Sanitary Permit Application

**CONDITIONAL APPROVAL**

**PLAN APPROVAL EXPIRES: 2025-8-1**  
**Plan Review: PWTS-082301559-C**

# Private Onsite Wastewater Treatment Systems ( POWTS) Inspection Report

STORMY  
LAKE

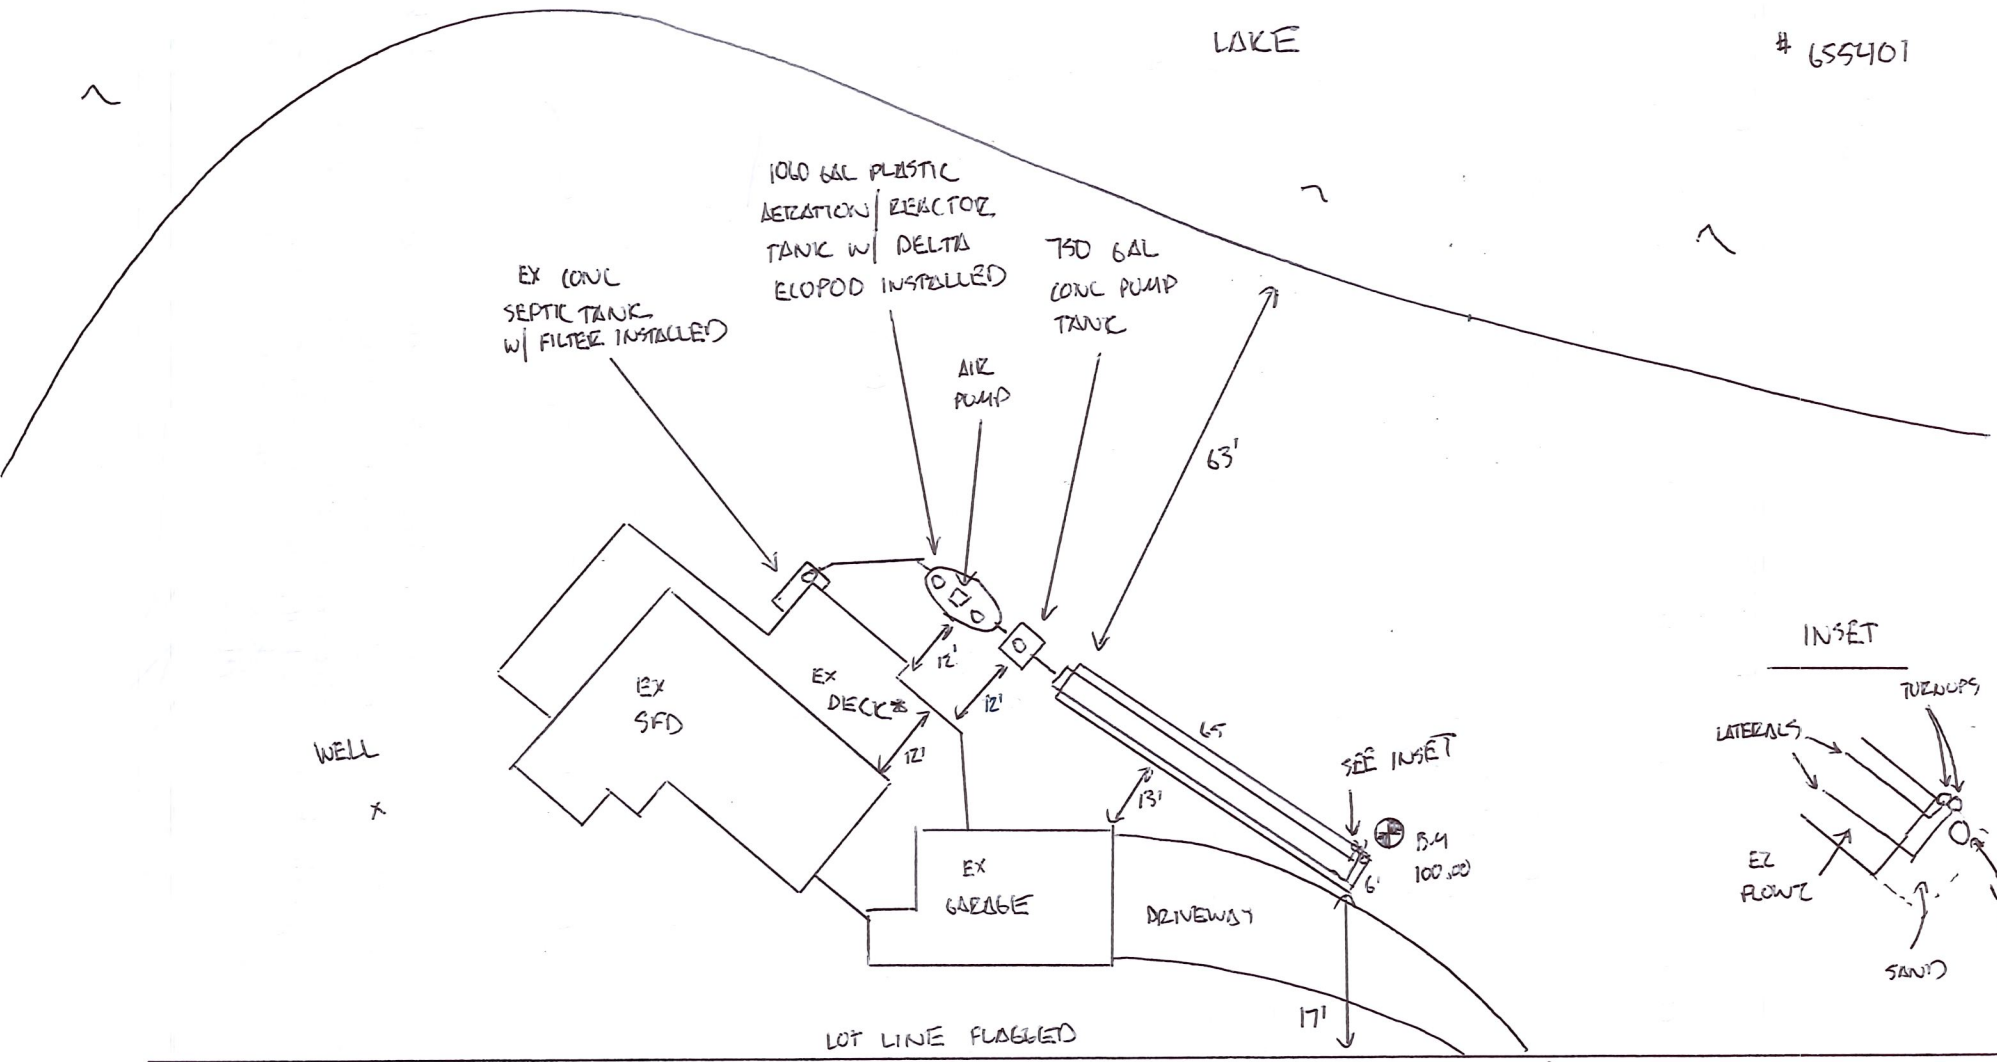
Delta EcoPool E60-N pre-installed in reactor tank installed per mfg instructions

Geotextile fabric in place

Upon excavation, it was determined that original field was not installed level, so portions of this field are 2-1 ft below original. System sand omitted from these areas but installed in all others.
